B.G.A. TECHNICAL COMMITTEE

TECHNICAL NEWSHEET

TNS 11/12/83

PART 1 AIRWORTHINESS AGGRO (The 1984 issue of B.G.A. Compendium of Airworthiness Directives Mandatory Modifications and Special Inspections for U.K. and Foreign Gliders and Motor Gliders will include the following additions:-

Subject: Air brakes, lower blade

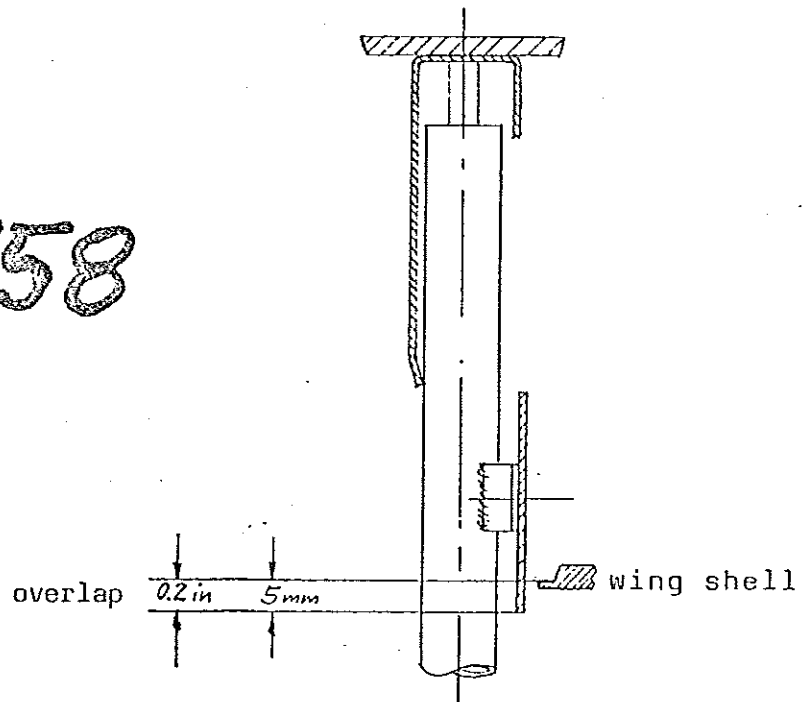
Reason: Possible jamming of lower air brake blade at high speeds

- 1) Assemble sailplane
- 2) With air brakes fully extended, measure overlap between lower blade and wing shell central to levers. When overlap is below 5 mm (0.2 in) proceed according to step 3.
- 3)a. Retract air brakes until overlap is at least 5 mm (0.2 in) at both wings
- b. Check extending height at inner lever, minimum is 150 mm (5.91 in). If below minimum, contact manufacturer.
- c. Rivet stop to air brake pushrod in cockpit from approx. 45° below horizontal such, that main bulkhead reduces travel to yield required overlap

Material: Stop 4R6-15, Steel blind rivet 4x10, (drill dia.4.1 mm, DN 20)

BCA MOD / ASK 21 / 83

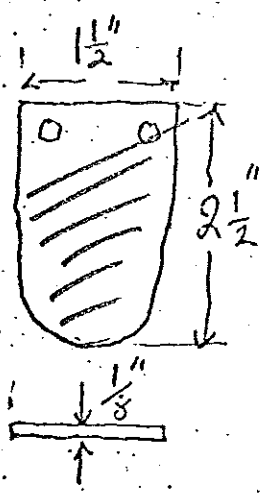
- 1.2 ASK 21 - Rear Canopy Locking There have been at least 6 cases, in the U.K. of the loss of the rear canopy in flight, due to improper engagement of one or both lock-bolts. Schleicher have been advised by the Midland G.C. to reconsider the design. In the meanwhile, strict checks should be made to ensure proper and full engagement of both bolts. Midland G.C. modification Ref. BGA/ASK/1/83 (attached) is recommended.

CANOPY MISALIGNED  
→  
WILL NOT CLOSE

THESE PLATES DO NOT SECURE CANOPY TO FUSELAGE. THEY SIMPLY ALIGN & LOCATE THE CANOPY. THEY DO NOT RESTRICT THE OPENING OF CANOPY IN ANY WAY IT WILL.

CANOPY ALIGNED  
& CORRECTLY CLOSED.
